PRELIMINARY ASSESSMENT REPORT

*For the Proposed 200MW Essex Wind Park Project
by Superior Wind Energy Inc.*

CAA ID No. 2002-078

FINAL Version

Figure 1: Transmission Facilities with the Proposed Essex Wind Park in-service

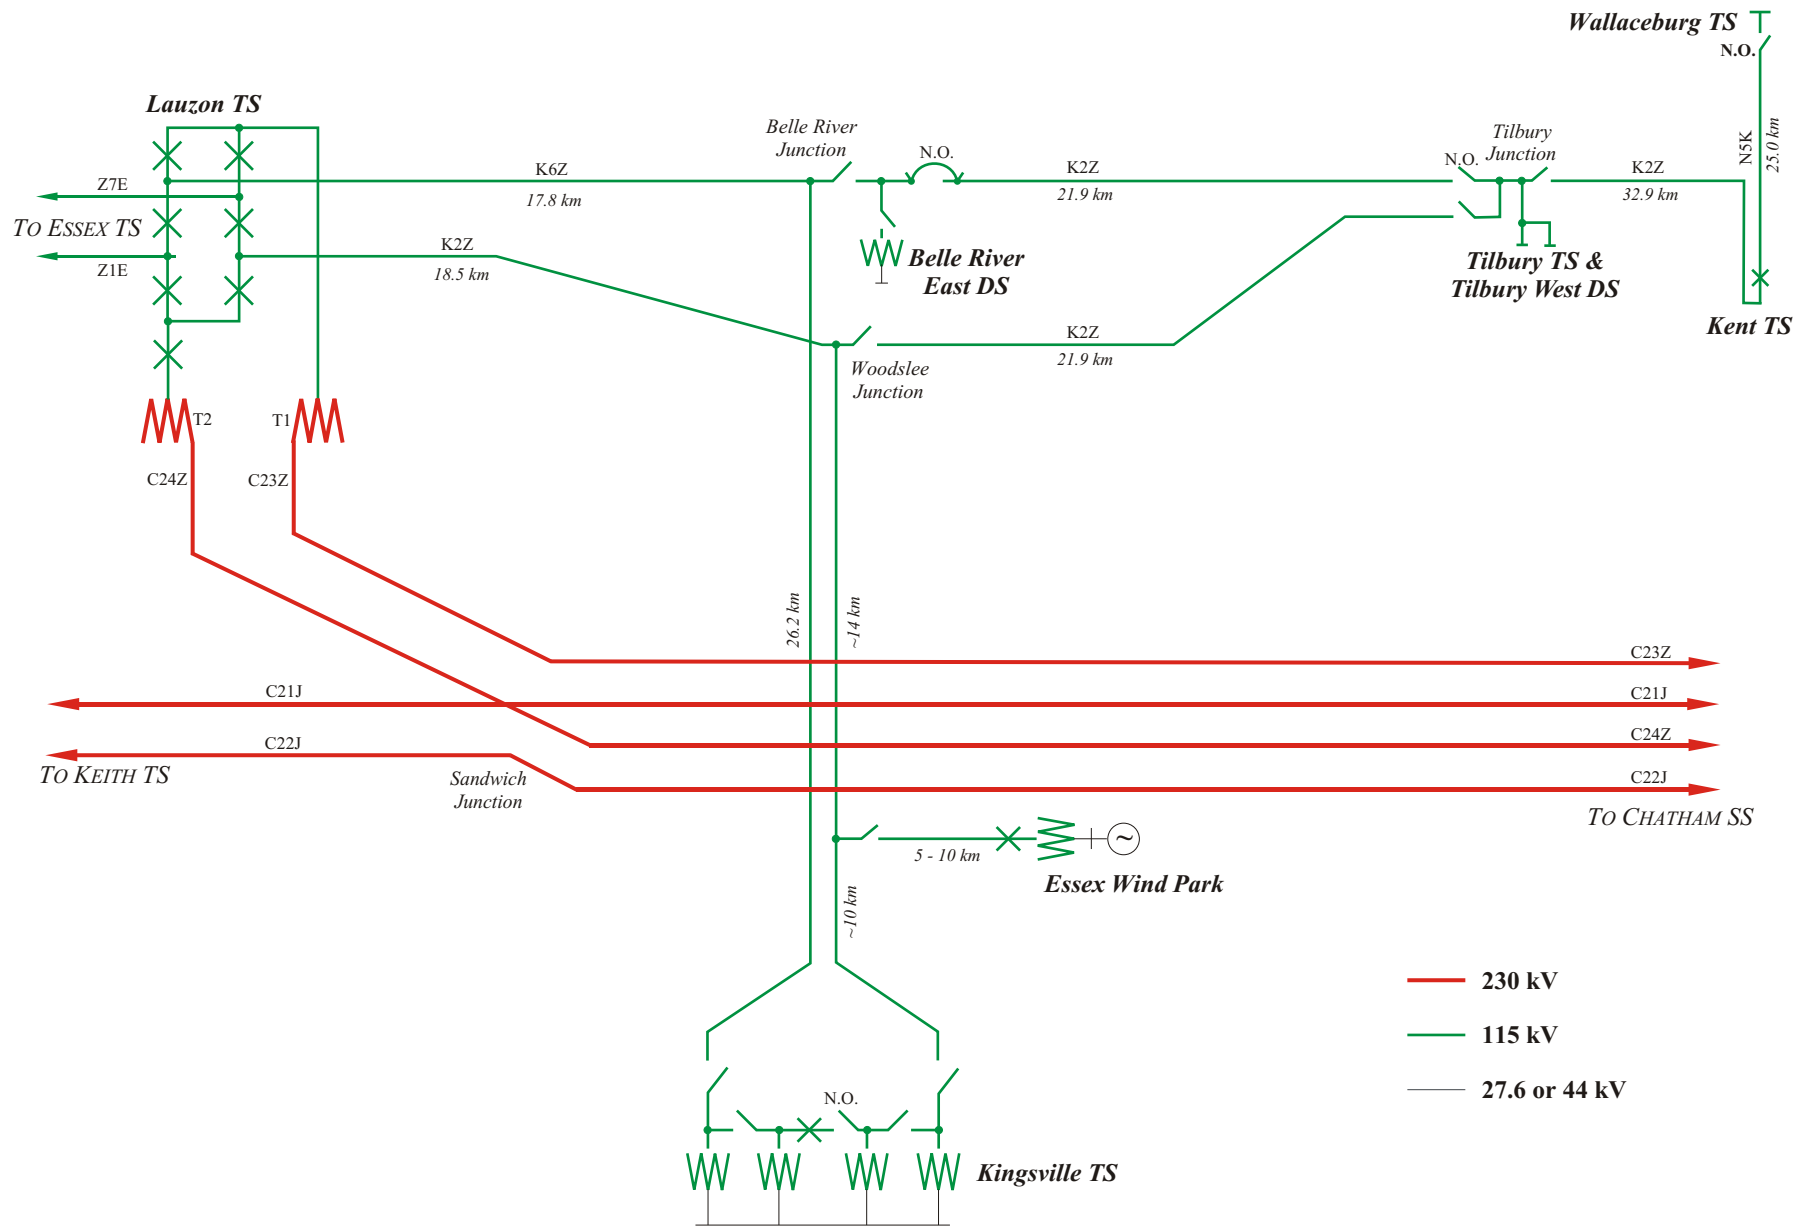
With its proximity to the Kingsville TS, the Essex Wind Park would likely supply most of the loads at Kingsville TS, a Hydro One Networks Inc. facility. As shown in Figure 1, Kingsville TS is presently supplied via the two 115kV transmission circuits K2Z and K6Z from Lauzon TS. The transformer station has four 25/33.3/41.7 MVA transformers, with transformers T1 and T3 connected to the line tap from K2Z and transformers T2 and T4 connected to the tap from K6Z. With the present proposal of a single connection to K2Z, the new Essex Wind Park would cause serious unbalanced loading on the four transformers at Kingsville TS.

A load flow study, which models the proposed connection of the Essex Wind Park, shows that about 75% of the Kingsville TS total demand would be supplied via the tap that also connects to the new wind park. The 2002 summer peak load at Kingsville TS was about 134 MW. With the present summer peak demand at Kingsville TS, a single tap incorporation arrangement would exceed the continuous ratings of the transformers T1 and T3 at Kingsville TS during peak load periods.

In order to incorporate the proposed 200 MW Essex Wind Park, two line taps connecting to circuit K2Z and K6Z would be required. Figure 4 shows two alternatives for two line taps incorporation arrangement. Both alternatives, subject to meeting Transmission System Code requirements and approval of Hydro One Networks Inc. would be acceptable to the IMO.

Figure 4: Essex Wind Park - Alternative Connection Arrangements

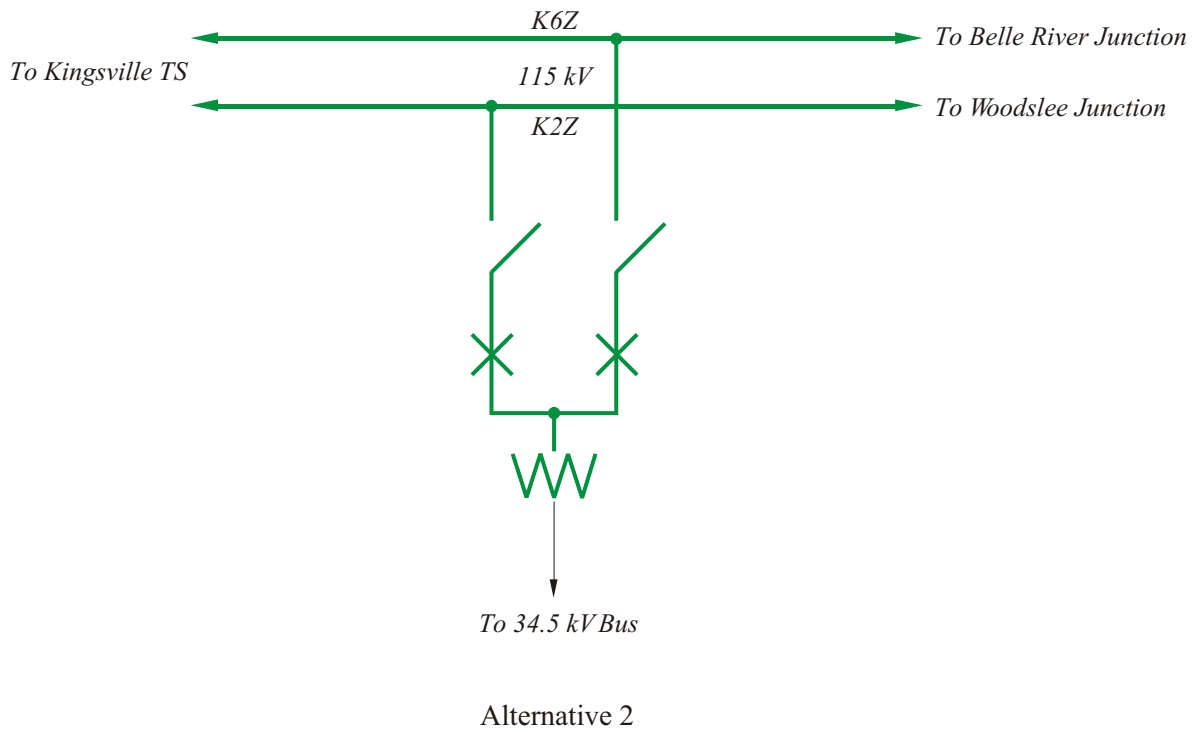
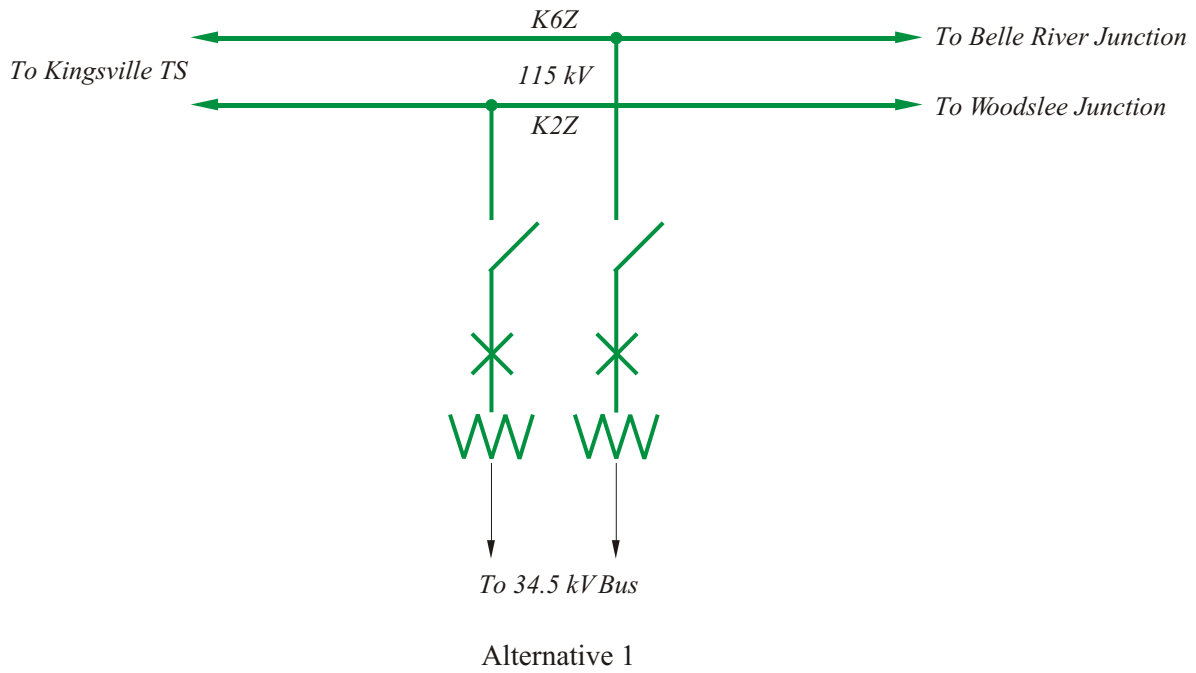
However, it should be noted that depending on the demand at Kingsville TS, contingencies involving either line tap, could result in power flows on the transformers at Kingsville TS exceeding their continuous ratings but within their short time ratings. But if either line tap had a protracted outage, the maximum output of the wind park would have to be reduced to respect the 10-day limited time ratings of the transformers at Kingsville TS. If the outage extended beyond ten days, output must be reduced further to respect the continuous ratings.

A dual connection to the IMO-controlled grid via K2Z and K6Z would provide additional benefit. A single-tap incorporation arrangement via K2Z would result in the removal of the Essex Wind Park for any outage involving K2Z, while the dual connection proposal would allow the wind park to remain in-service for normally cleared faults involving either K2Z or K6Z.

Based on the above discussion, the following assessment is based on the assumption that a dual connection to both K2Z and K6Z (Alternative 2) would be implemented for the incorporation of Essex Wind Park.
